# Planning and Rights of Way Panel

For Item 8 - **194 Bassett Green Road**

## Notes for Andrew Amery and Laura Treagus following their site visit to 192 and 194 Bassett Green Road on Wednesday, 13<sup>th</sup> February 2019

### 1. Annotated notes relating to Drawing No. BH/P/04 (re-submitted January 2019) and our plan drawing headed “Bassett Holt 192 / 194 / 196 Bassett Green Road”

# Bassett Holt

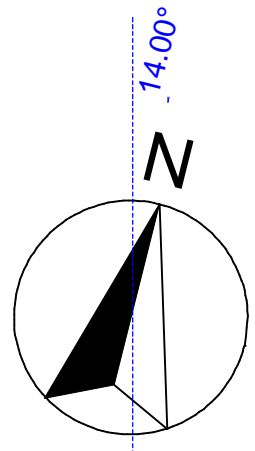
E. Drawing BH/P/04 shows chamfered window and door measurements as 1400mm. These are the measurements of the glazing and not the actual external wall measurements. Our plan drawing “Bassett Holt etc.,” shows these as 1700mm as these are the external wall measurements of the chamfered corners. When the 45° line is then drawn from the external wall measurements, it results in a line that does not meet the windows of the neighbouring properties at the points shown on BH/P/04, which in themselves are incorrect.

<b>PROJECT:</b>	PROPOSED ORANGERY AT 194 BASSETT GREEN ROAD, SOUTHAMPTON, SO16 3TQ
<b>DRAWING NO:</b>	BH / P / 04
<b>SCALE:</b>	1:50
<b>DATE:</b>	NOV 2018

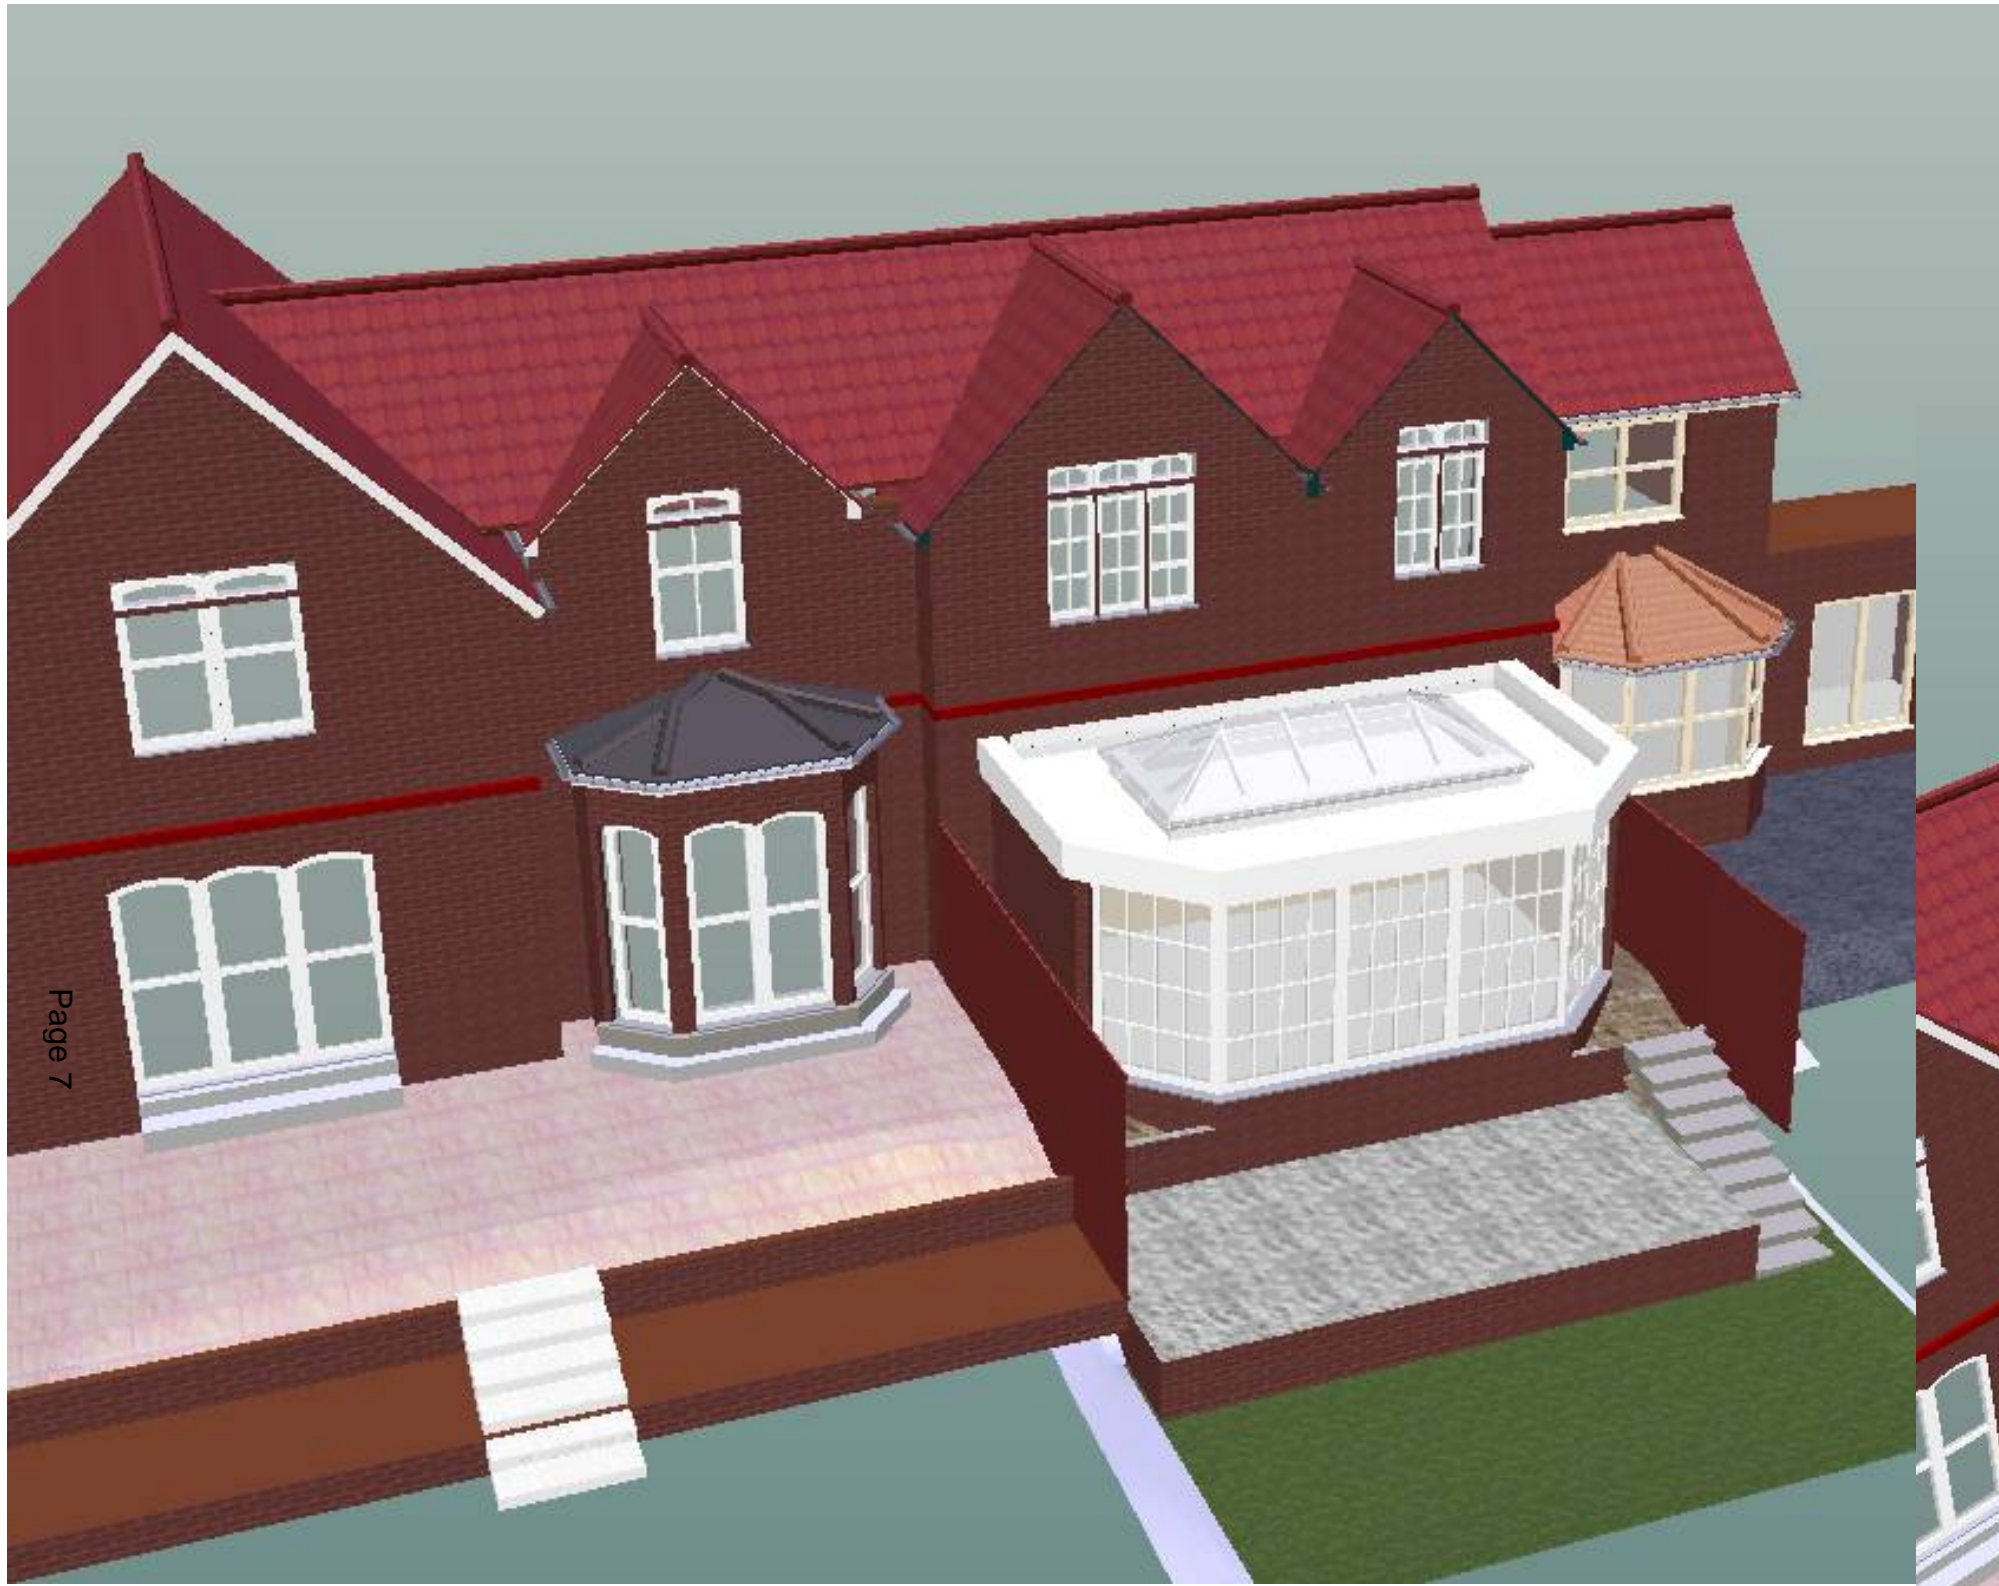
A. The scale shown on BH/P/04 is not correct. When applied to the drawing, all dimensions are smaller. For example, the 5m shown on the scale, when applied to the lantern, makes it appear smaller.

B. Measurements outside the boundary of 194 are important and show an incorrect relationship to the bay windows of the adjoining properties. This is highly relevant to the application of the 45° rule. On plan, this gap is shown as 1000mm – actual gap 770mm

C. As above, the gap is shown as 650mm – actual gap 490mm

D. As a terraced row of houses it is the nearest window of 192 and 196 that should be used for the application of the 45° rule. The plan shows the 45° line applied from the centre of the bays, not the nearest window.

Schematic Representation Only

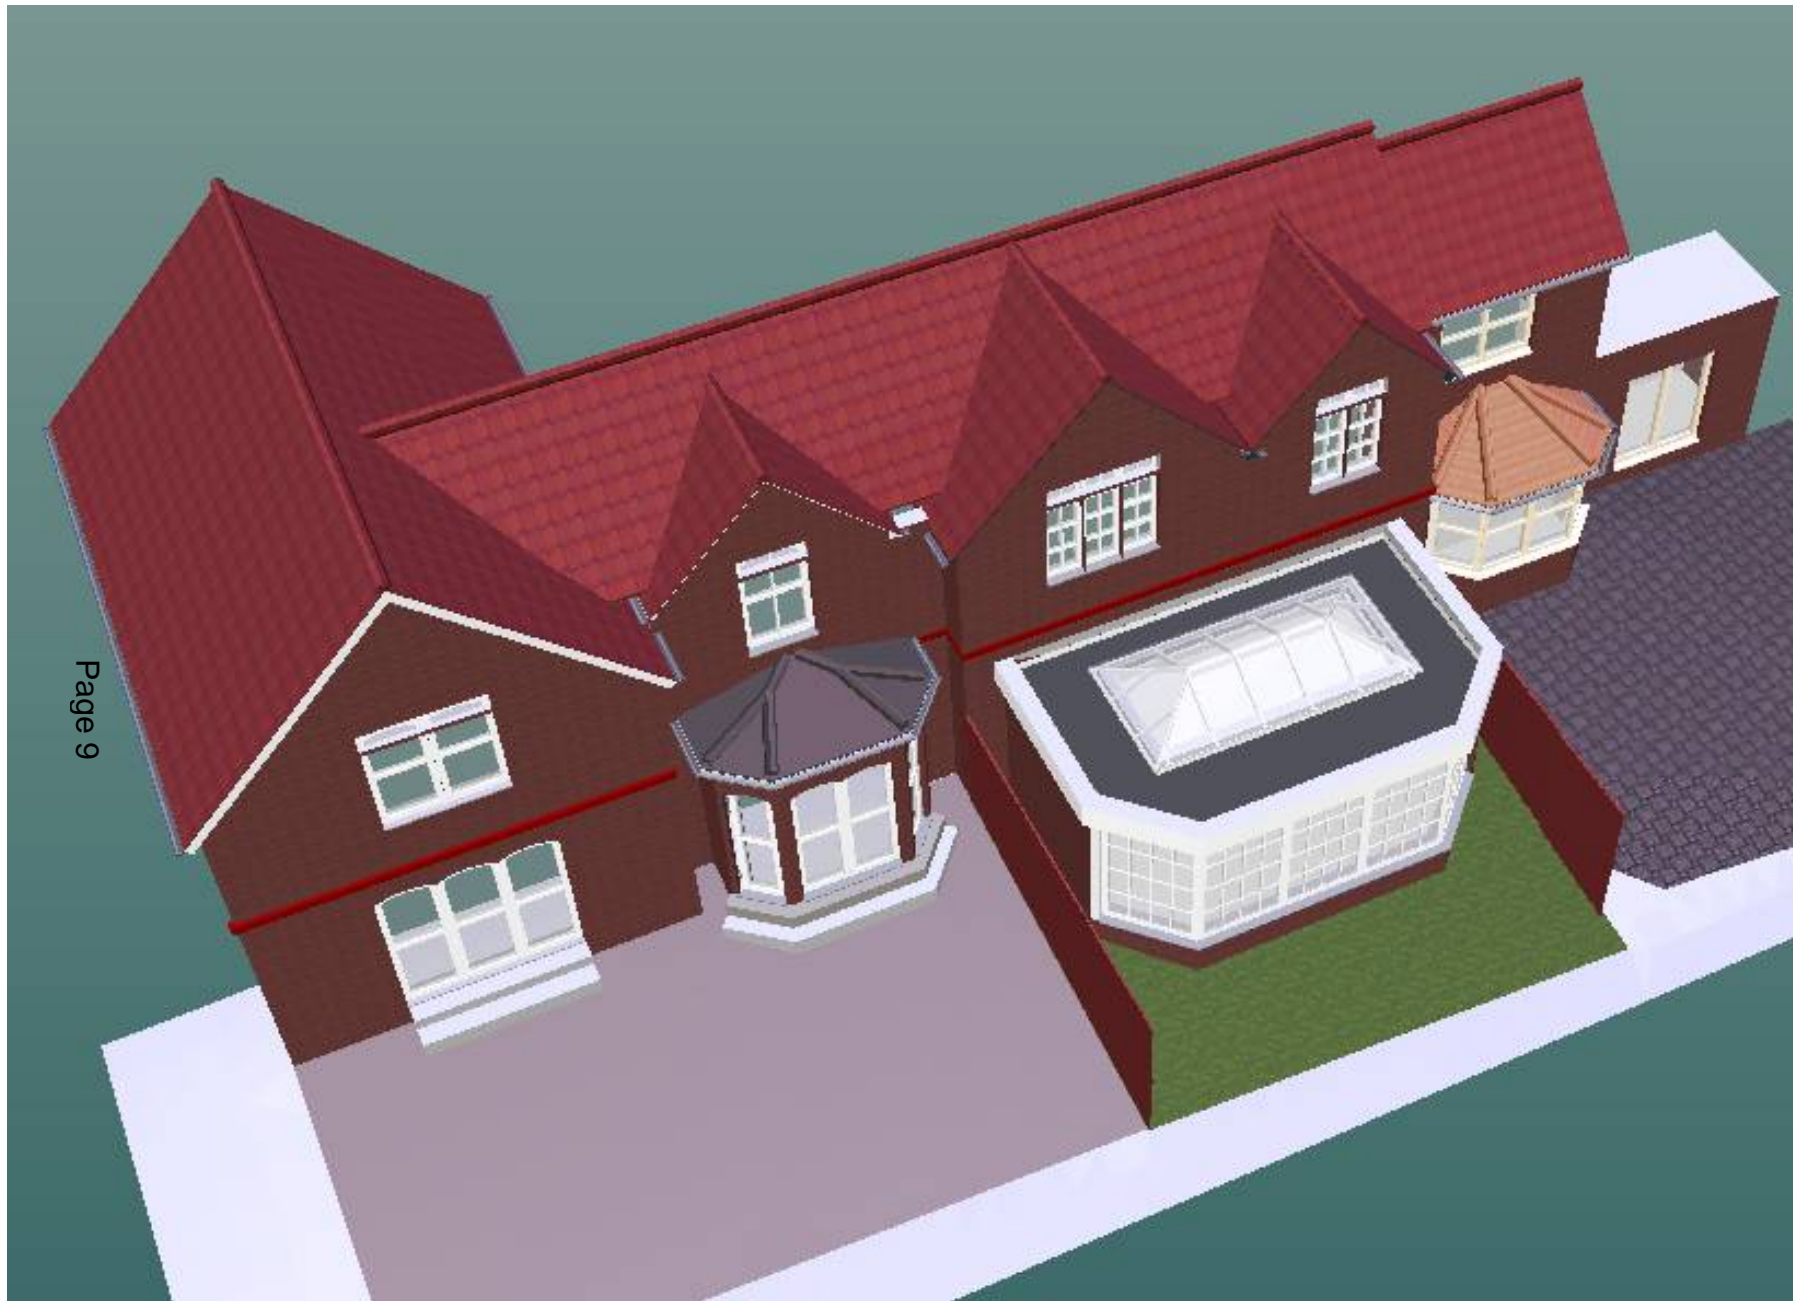
The schematic shows the extent to which the proposed extension extends beyond the existing patios of 192 and 196 and its impact in terms of:

- Its dominating nature and visual impact from all aspects of the patios and rear gardens of 192 and 196
- Its overbearing scale and appearance, and
- It being out of character and failing to integrate with this historic Victorian building.

1. *There is a fence line and garden drop of approx. 2000mm at 192 impacting on privacy.*
2. *We have been unable to insert the patio at 192, the extent of which can be judged from the plan diagram showing it being parallel with the middle of the chamfered door. It then drops 2000mm to garden level accessed by steps.*
3. *Nevertheless, we believe the schematic shows the extent to which the proposed extension dominates and is out of scale to 192.*
4. *Beyond patios and steps of all 3 properties, there is grass and flower beds (shown as teal blue on the schematic)*
